PROJECT 2023-007680-HDRB. 128 Camino Santiago. Downtown & Eastside Historic District.

BOARD ACTION

memo

RE: Historic Districts Review Board
Revised submission post H-Board review
128 Camino Santiago

Exception to Section 14-5.2(D)(5)(a): The applicant requests an exception to alter openings on a primary façade by infilling windows and doors.

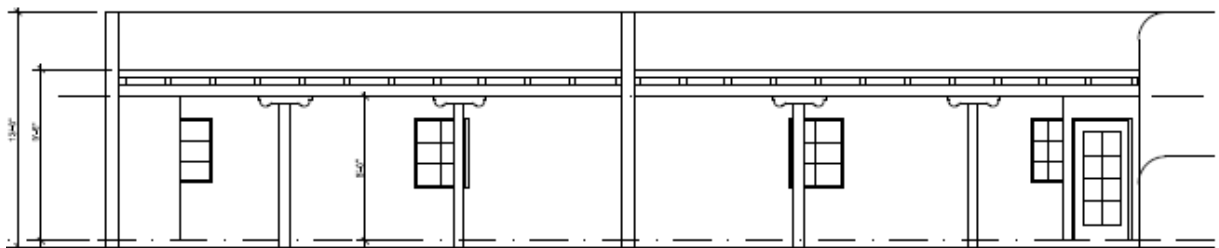
Staff Response: Staff agrees that this residential structure, which is one of the three located in the Plaza del Monte compound, has changed use from a multi-family unit to a single-family unit and this makes the need for the multiple entries obsolete. The overall design of the structure is not being altered so it will not damage the character of the district or neighborhood to alter the fenestrations to meet the current use of the structure.

Staff Response: Staff agrees that this residential structure, which is one of the three located in the Plaza del Monte compound, has changed use from a multi-family unit to a single-family unit and this makes the need for the multiple entries obsolete. The overall design of the structure is not being altered so making it more compatible with the current use will prevent complications for the family that lives in it.

Staff Response: Staff agrees that as a single-family unit the single door and other opening changes are compatible with the design options for the interior remodel of the structure and blend in with the rest of the compound. The applicant did consider closing off the unnecessary openings on the interior only of the structure; however, this did not accomplish removal of confusion for what constitutes as the entrance to the single-family residence.

PROPOSED NORTH ELEVATION (NO YARD WALL)

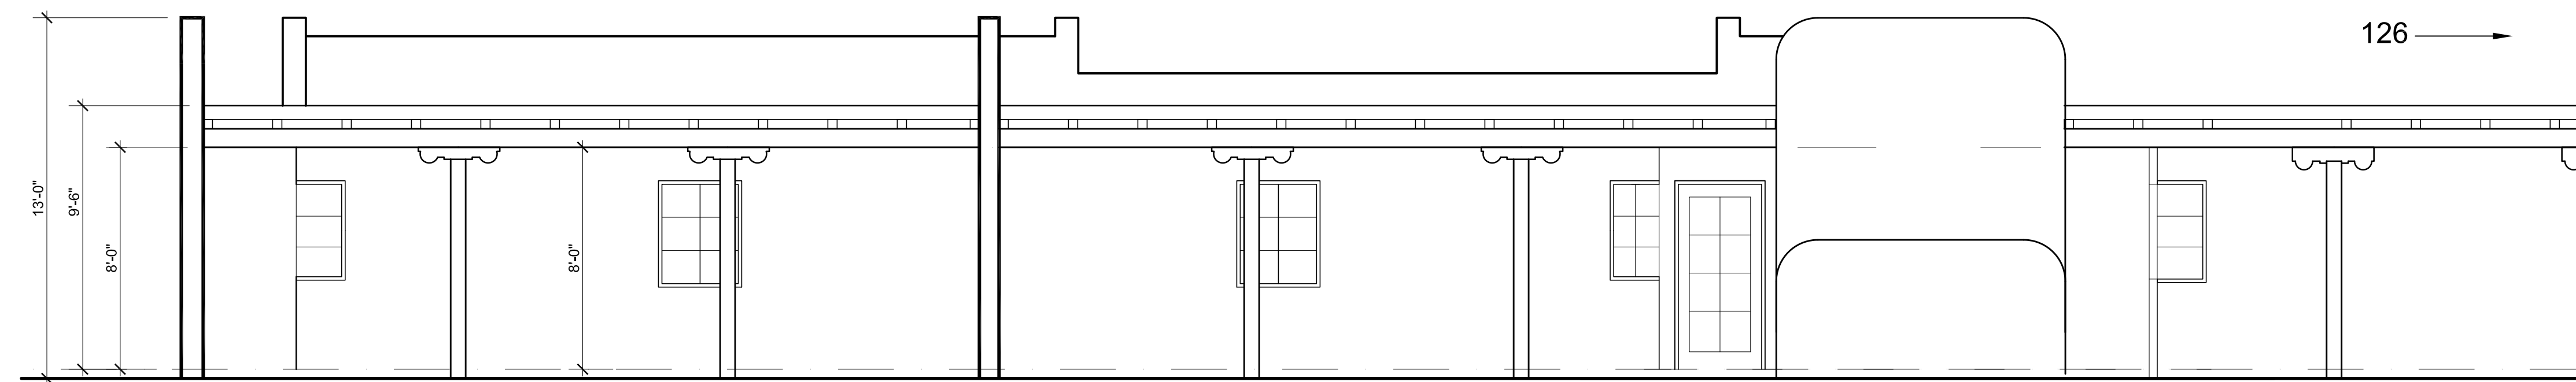
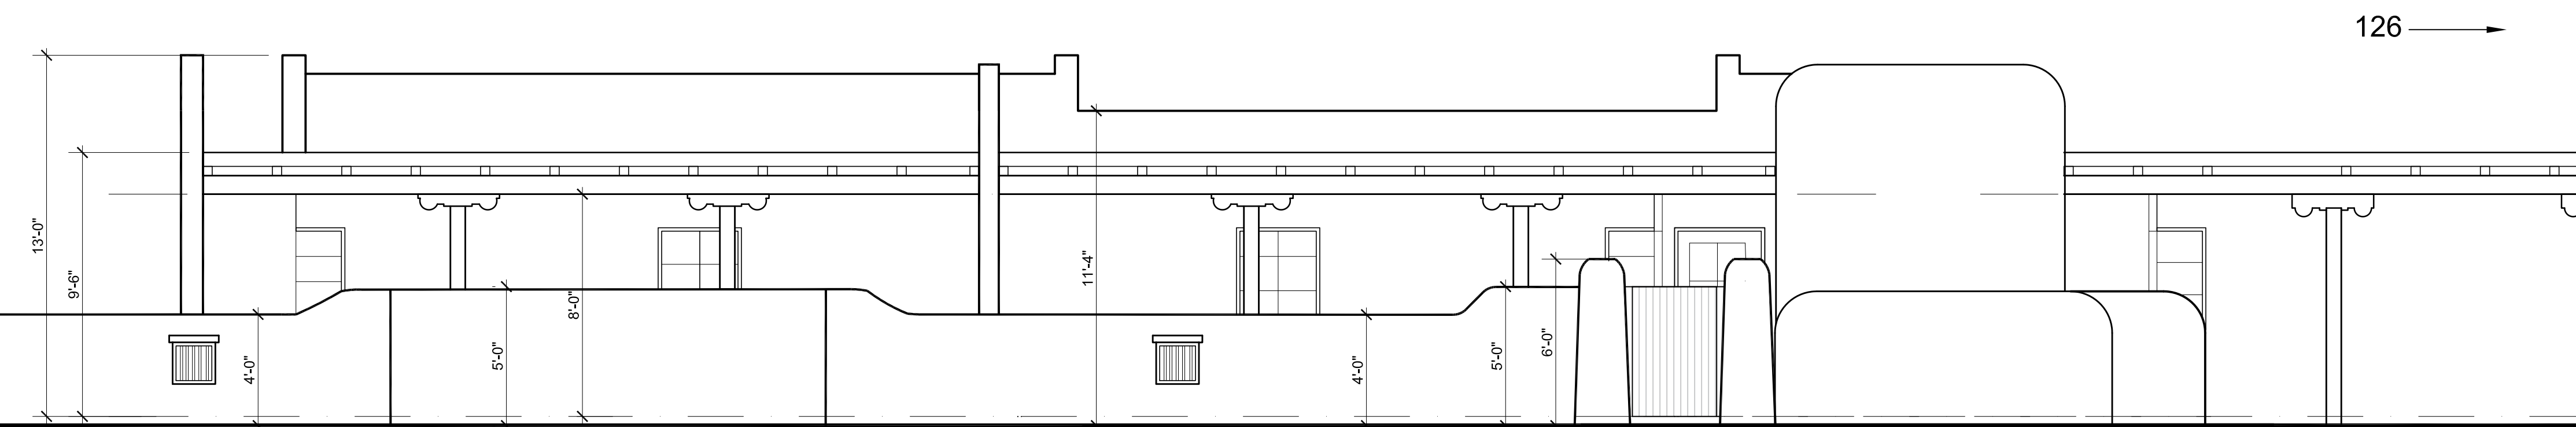
1. the north elevation existing steel casement windows that are being retained be repaired rather than replaced,
2. the existing wood entry door be repaired and reused,

6. the front yard wall on the east and north retain the multiple height design but the heights be lowered to 3½' and 4½', and
7. the applicant shall update the drawings and submit window selections to the staff for final approval.

PROPOSED SOUTH ELEVATION

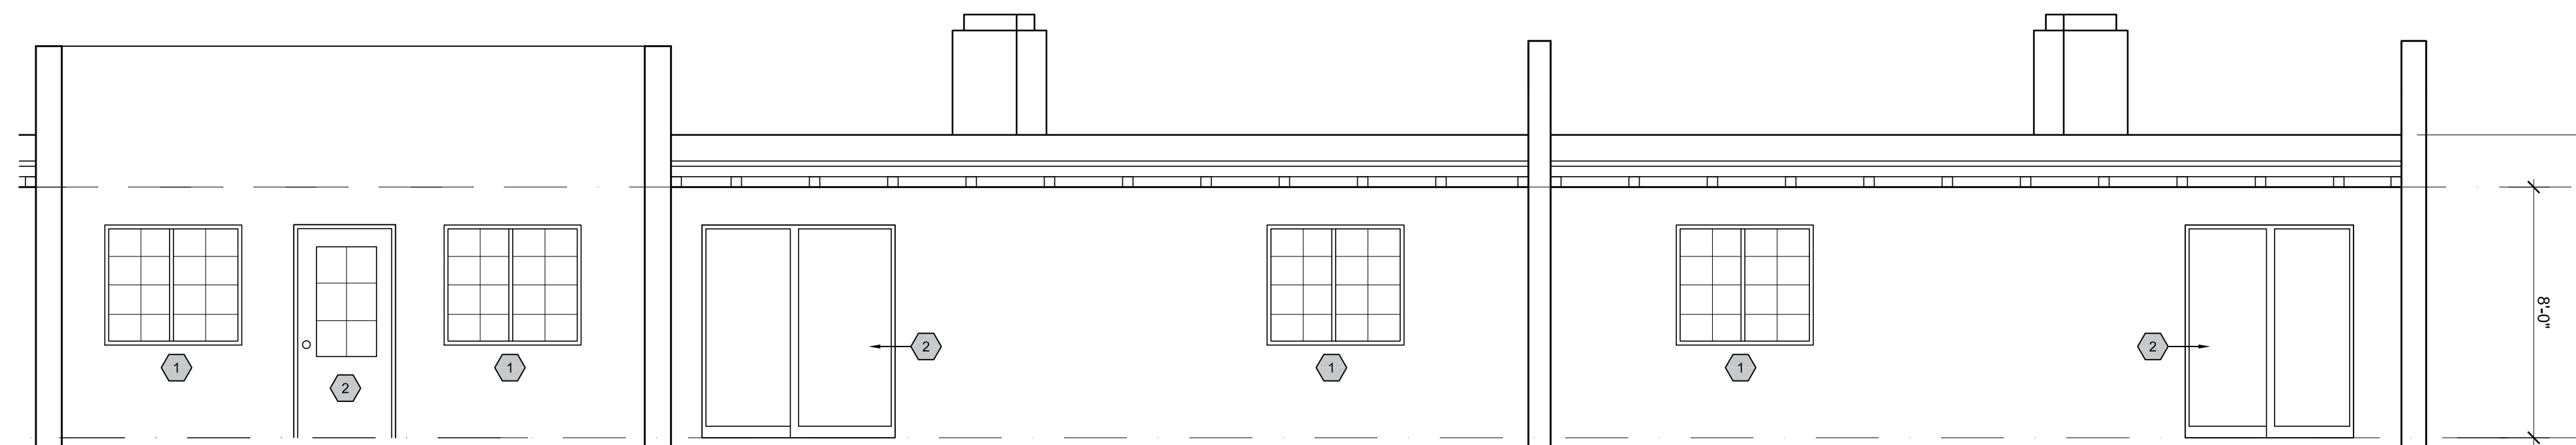
4. the garage and bunkhouse structure be reduced in height a minimum of 1' with a preference being 1½' and 2' to be more in scale with the historic part of the building,

5. the southern property yard wall and gate in the motor court be lowered to 5'0" in height and pilasters, modulations, and offsets be incorporated in the design as required by the fence and yardwall guidelines,
